# ESTABLISH RWY 7 ROLLOUT RVR PHASE I BARROW, ALASKA FOR CONSTRUCTION

## PHASE I SCOPE

CHANGED SOURCE OF POWER TO EXISTING FAA-OWNED TRANSFORMER.  
DATE OF REVISION: 4/2/2012

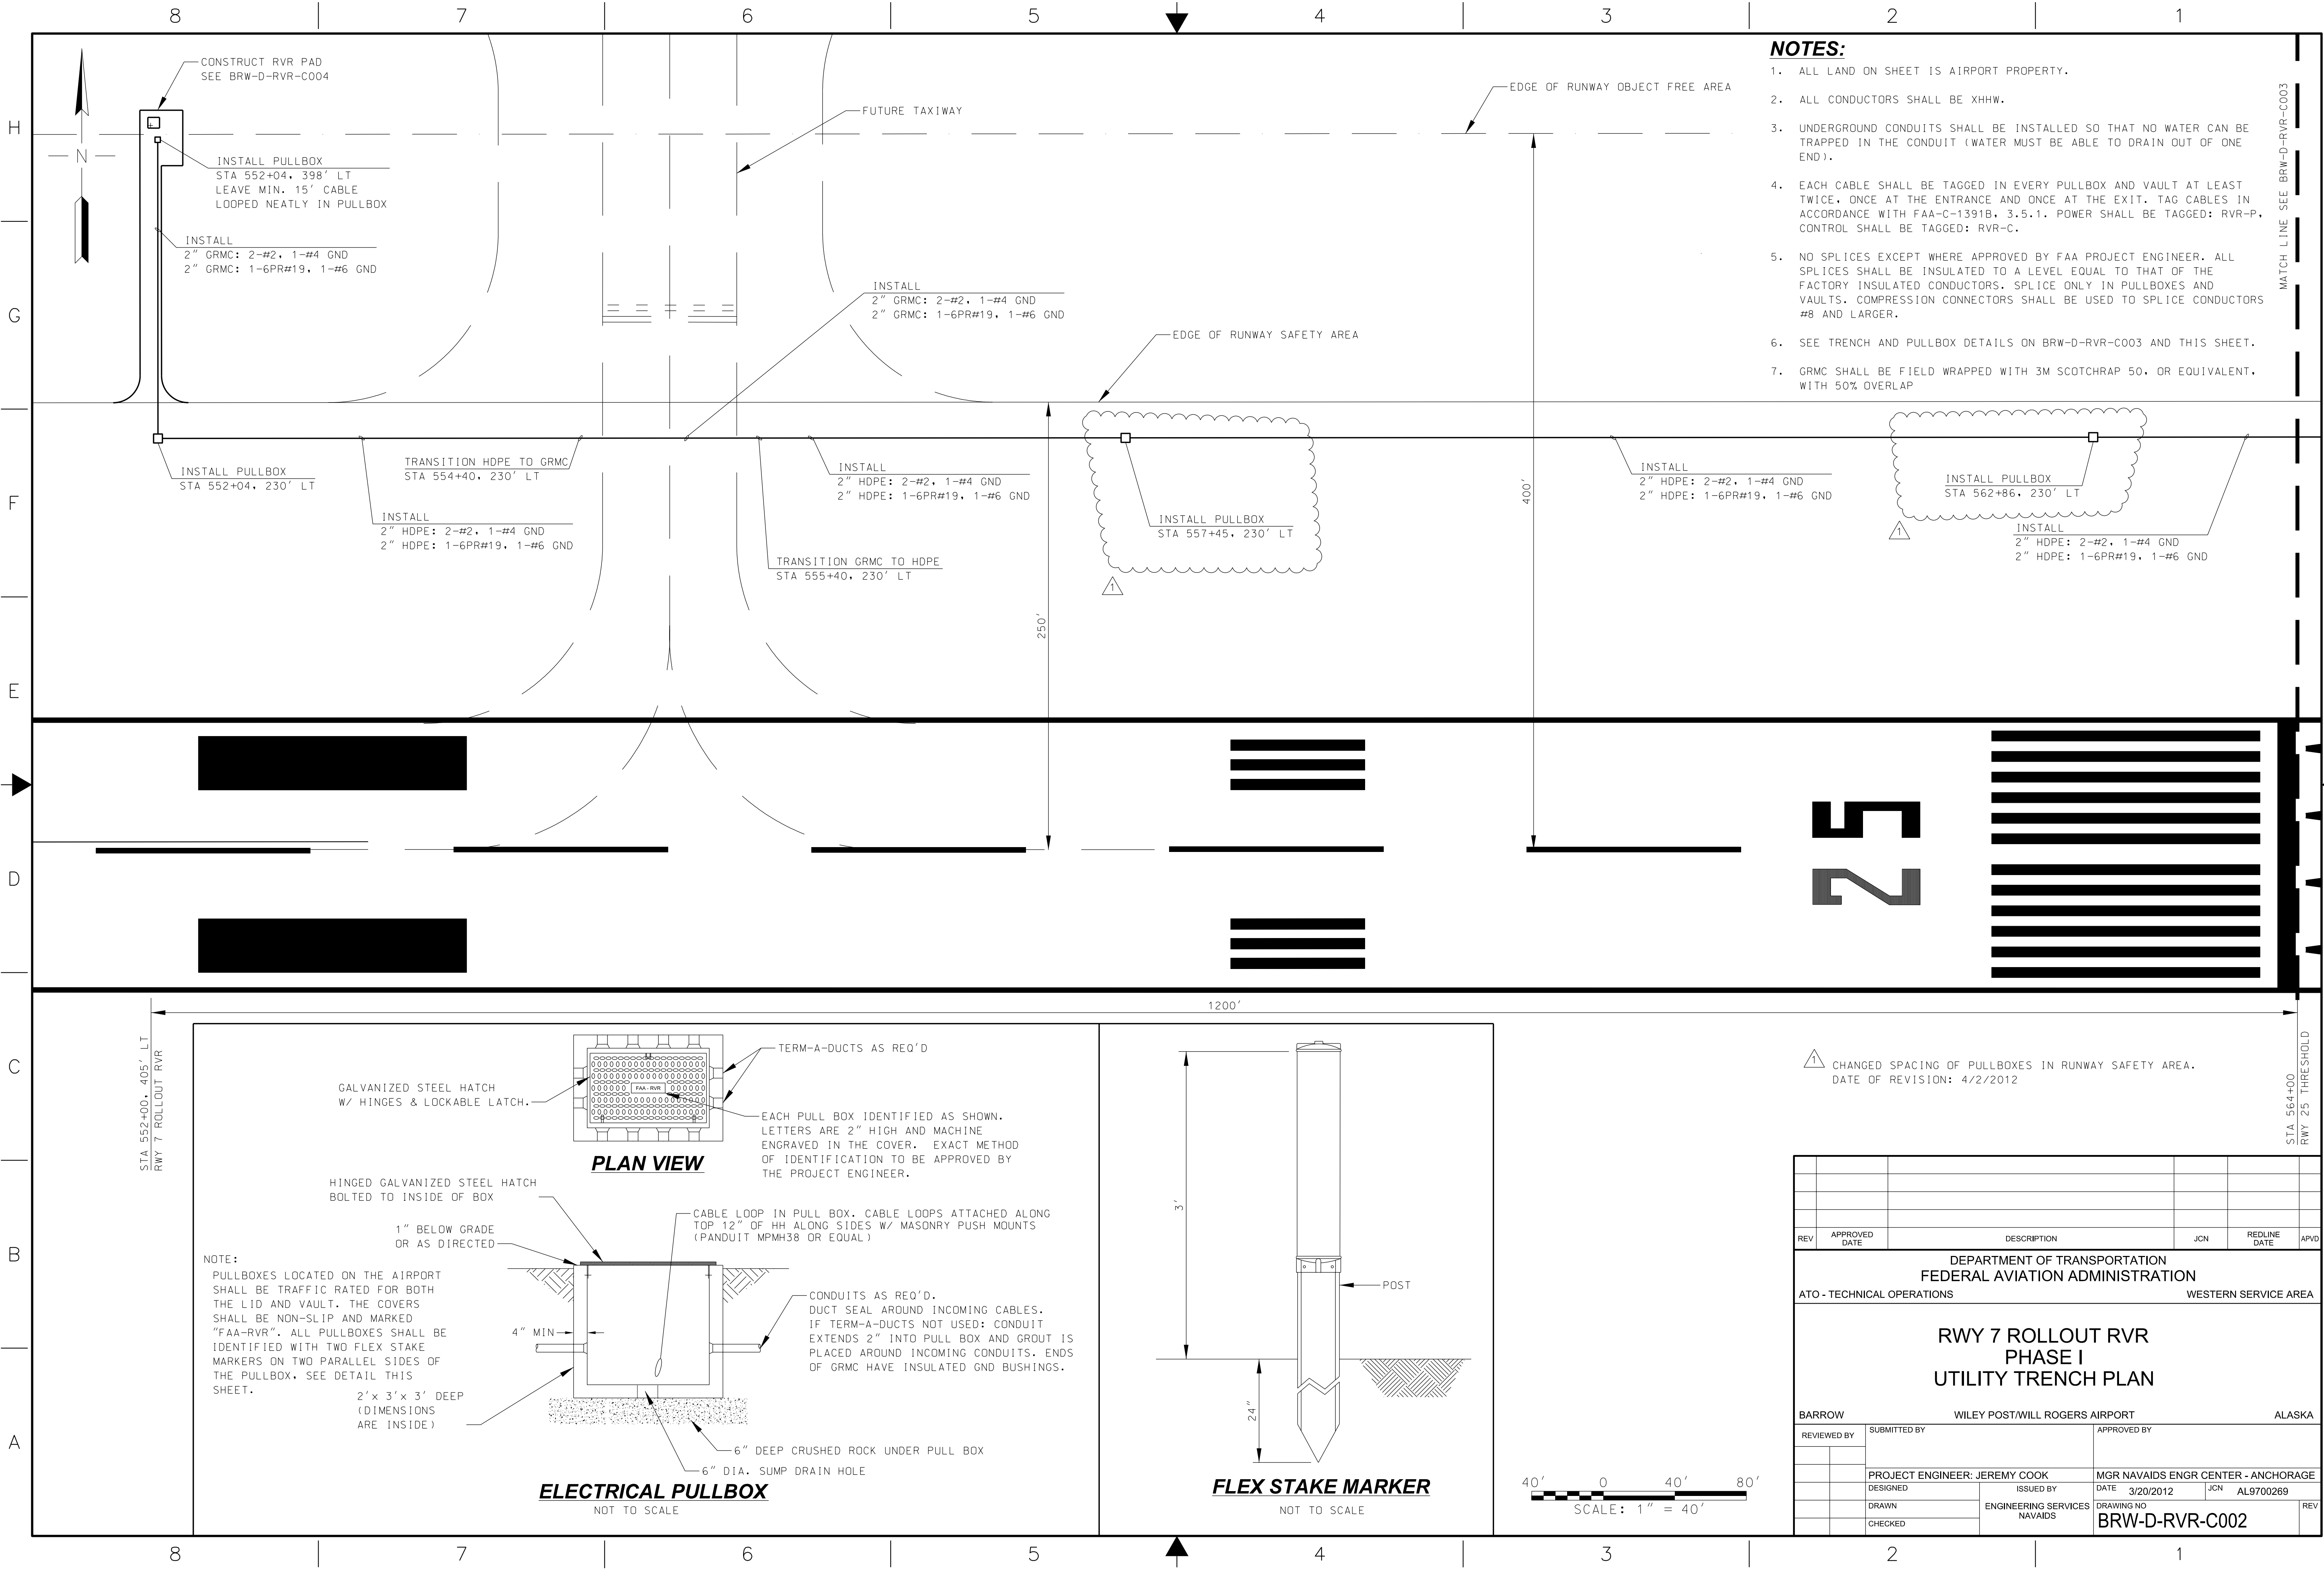
1 CHANGED SPACING OF PULLBOXES IN RUNWAY SAFETY AREA.  
DATE OF REVISION: 4/2/2012

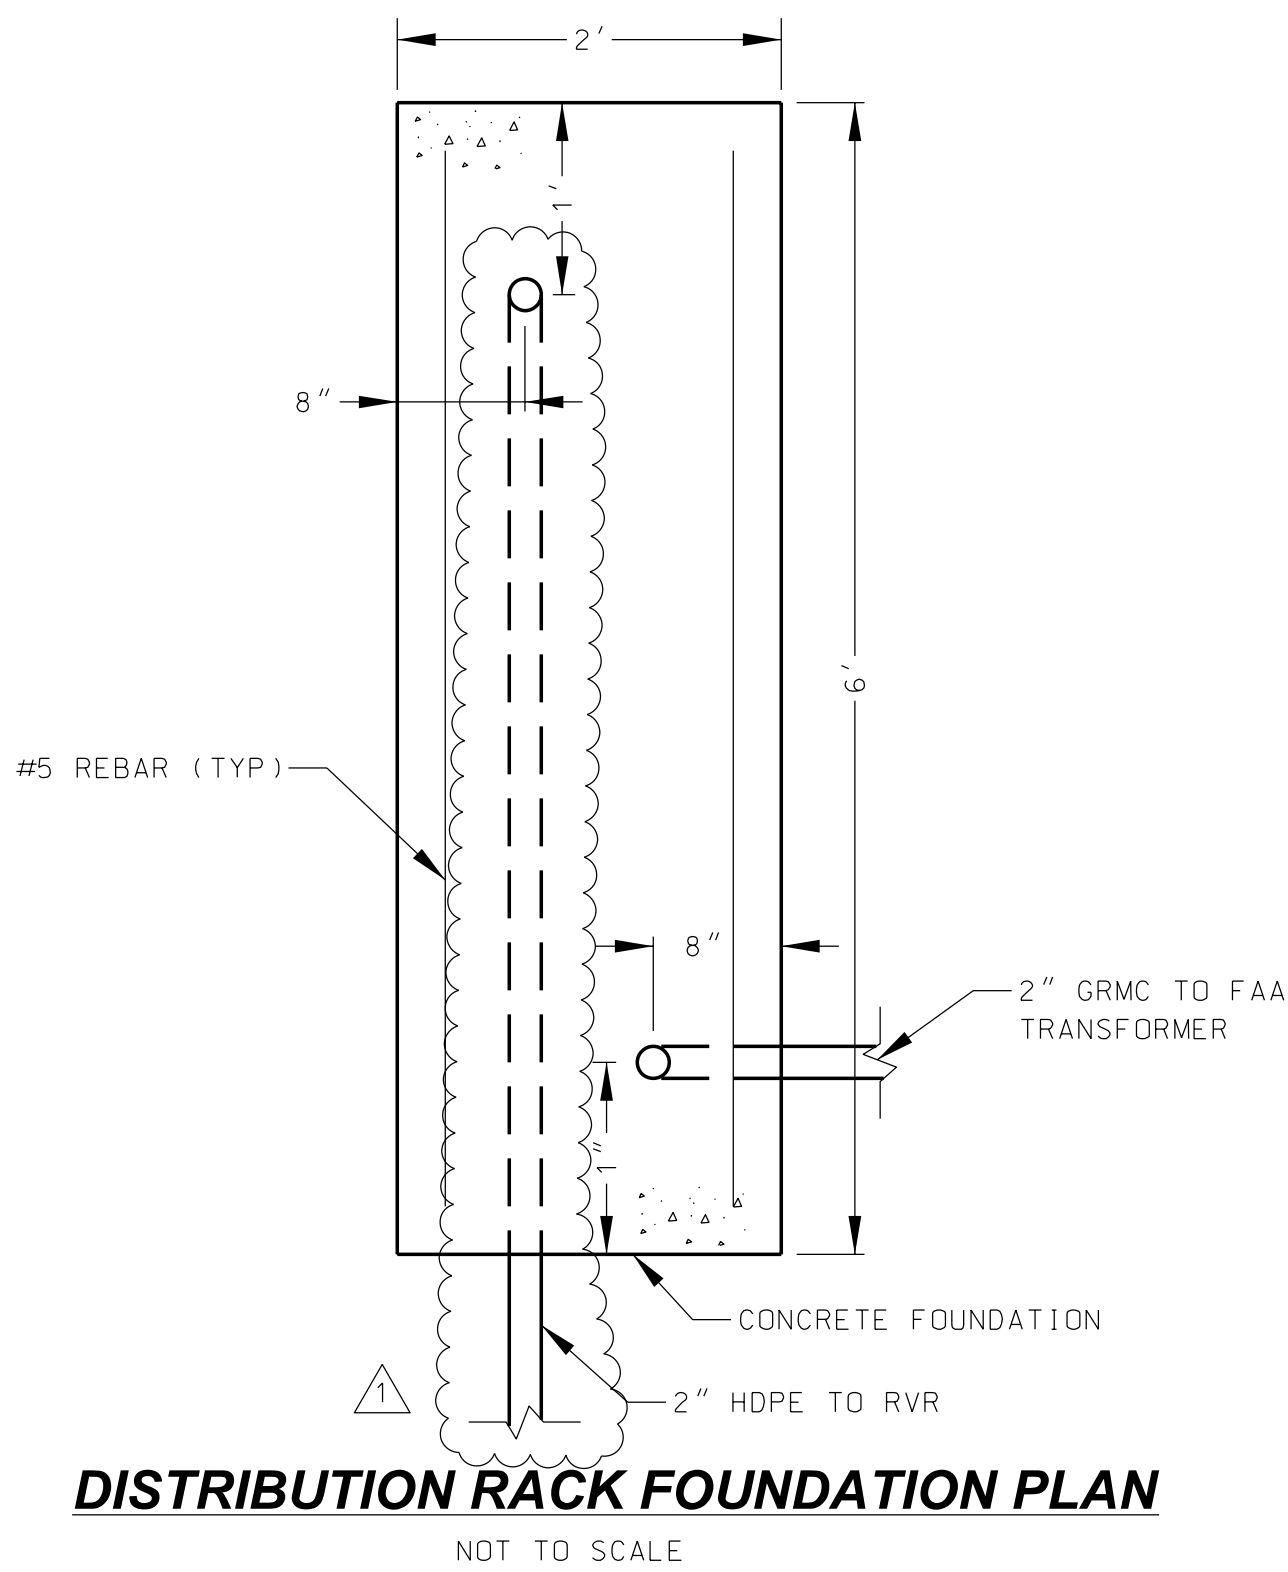
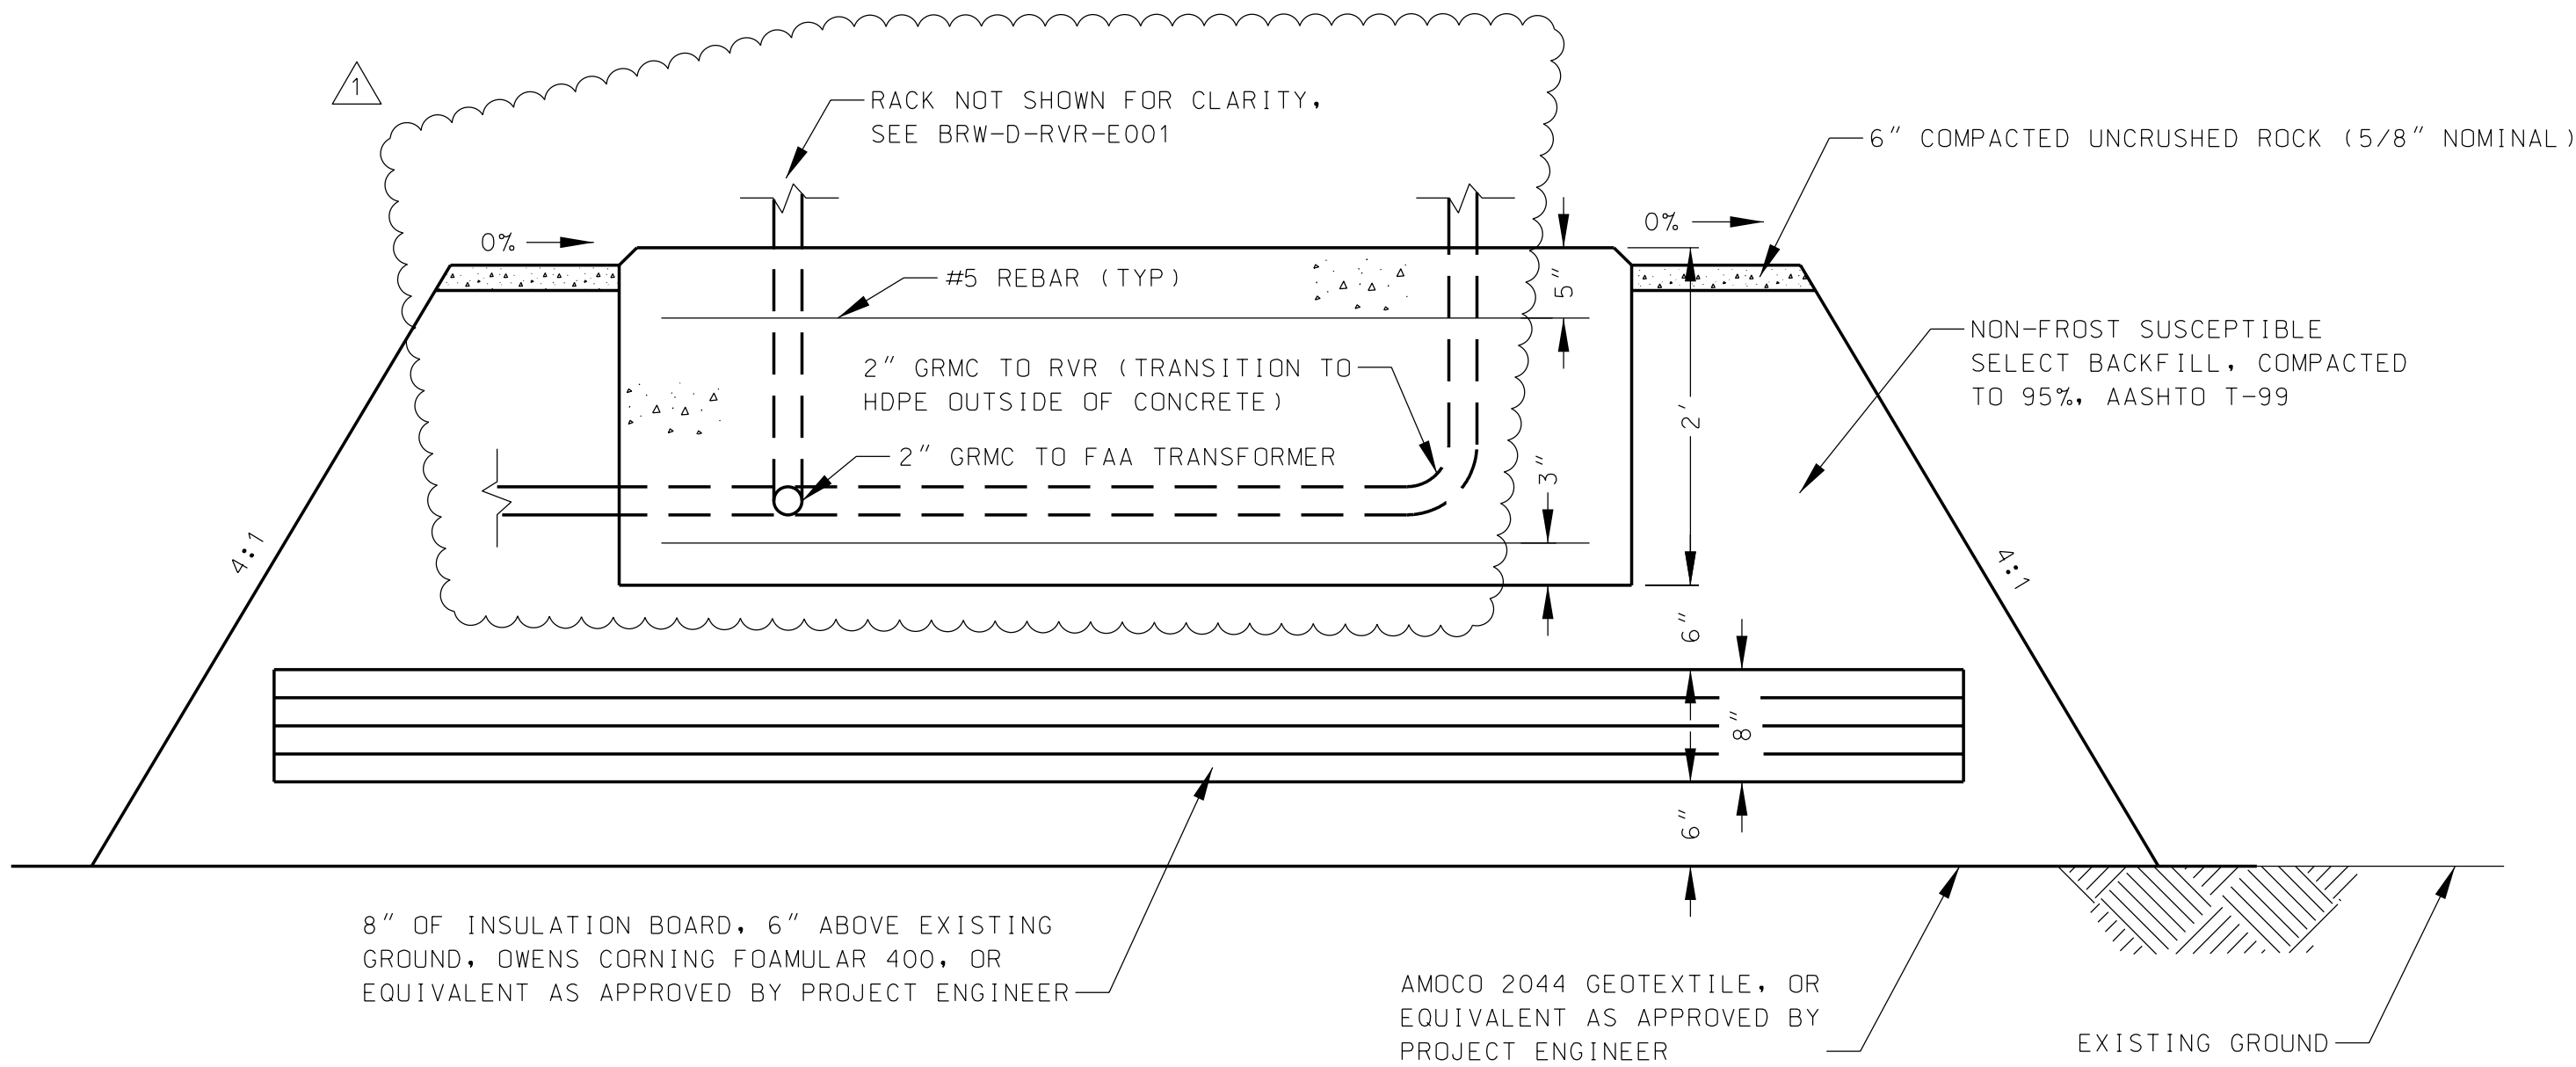
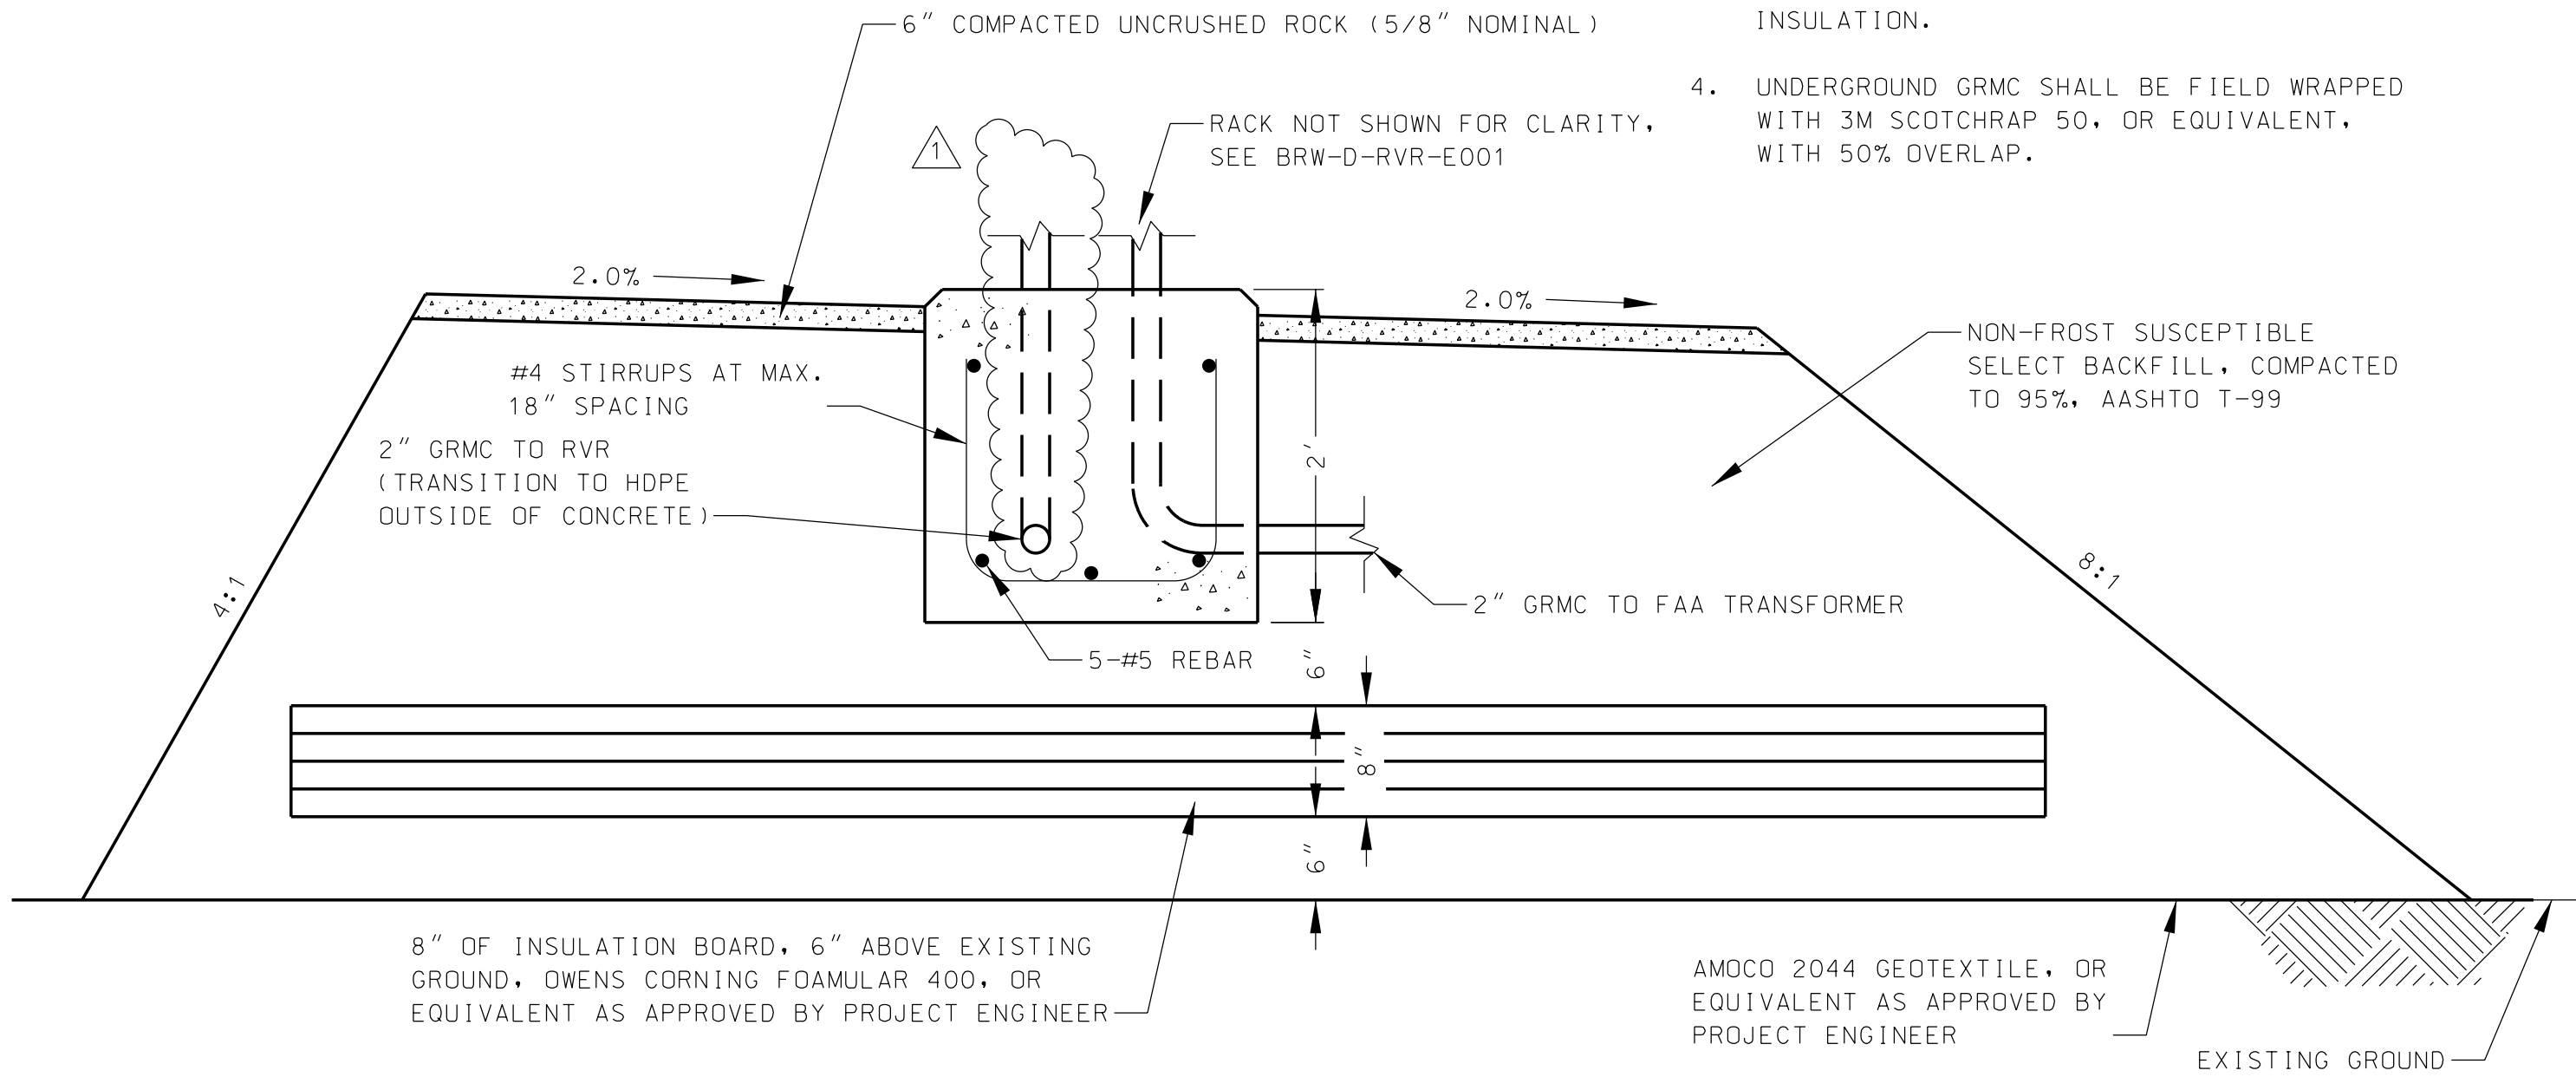
1 CHANGED ROUTING OF CONDUIT TO RVR.  
DATE OF REVISION: 4/2/2012
